STAFF PAPER

Review of San Francisco Public Utilities Commission Integrated Resource Plan Filing

June 2019 | CEC-200-2019-007

Figure 1: SFPUC and Energy Commission Energy Forecasts 2019-2030 (GWh)

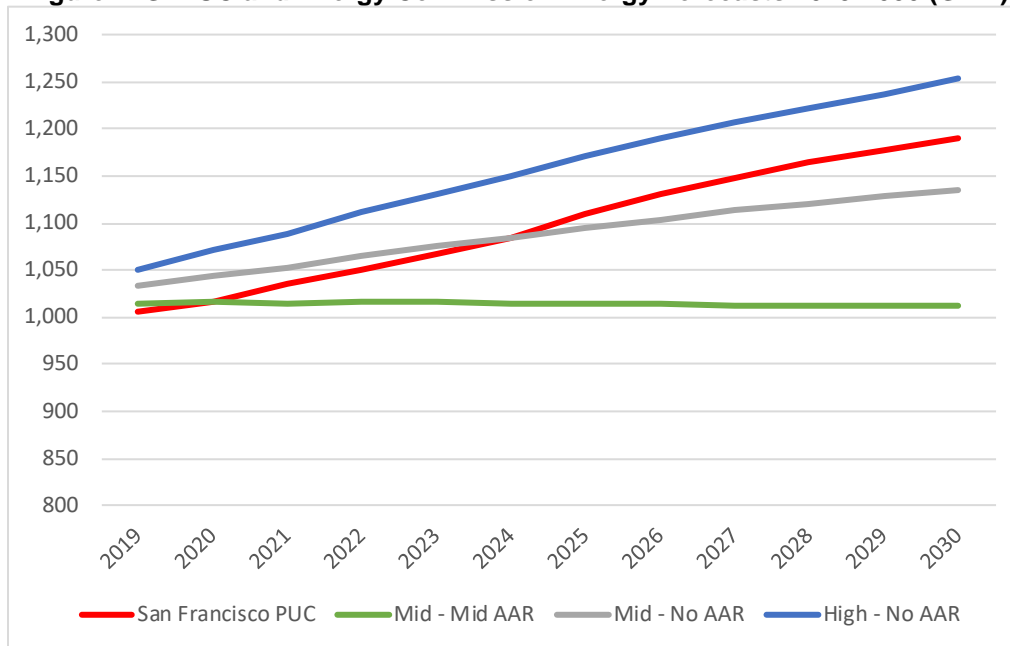
The SFPUC projected annual growth over 2019 to 2030 of slightly more than 1.5 percent, while the Energy Commission’s “mid demand, mid additional achievable resources” forecast shows no growth.⁸ The annual growth rate projected by the SFPUC is comparable to the Energy Commission’s “high demand, no additional achievable resources” scenario of 1.6 percent.

The Energy Commission’s forecasts of the SFPUC’s energy demand growth, because of its small size (less than a 200-MW peak demand), are based on a growth rate for the Pacific Gas and Electric (PG&E) planning area, which is driven largely by assumptions regarding demographics and the economy. Most of the SFPUC retail sales are to municipal departments, whose demand is less influenced by changes in economic conditions and demographics than are residential, commercial, and industrial consumption. Consequently, the utility used information from the city’s long-term capital planning process to forecast demand growth arising from “new” municipal customers; capita investments on the part of the city that increase its energy needs are not correlated with the economic and demographic factors that drive residential, commercial, and industrial demand.

The utility assumed a 0.5 percent annual growth rate for retail sales to existing municipal customers based on historical trends.

The remaining growth was projected to result from the SFPUC's efforts to acquire new retail customers. At the time the SFPUC IRP was adopted, the utility anticipated increasing its retail sales of surplus energy rather than selling to wholesale buyers. This component of load growth was not included in the Energy Commission's lower demand forecast.

More recent SFPUC forecasts, prepared subsequent to this IRP, assume lower goals for retail sales, which will be reflected in future updates to this IRP. Given the utility's substantial surplus of energy and capacity in the near and long term, these changes are not expected to have a substantial impact on resource procurement over the first five or more years of the planning horizon. Accordingly, the forecast used in the IRP filing is consistent with the *POU IRP Guidelines* requirements.

Figure 2: SFPUC and Energy Commission Peak Forecasts 2019-2030 (GWh)

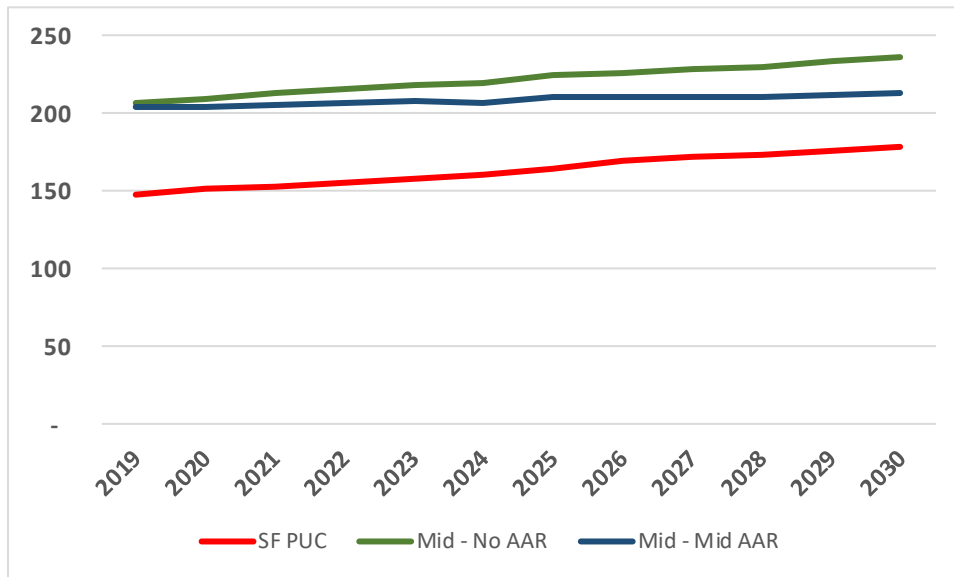
The Energy Commission estimate is well above that of the SFPUC and will be reassessed in the next IEPR forecasting cycle.
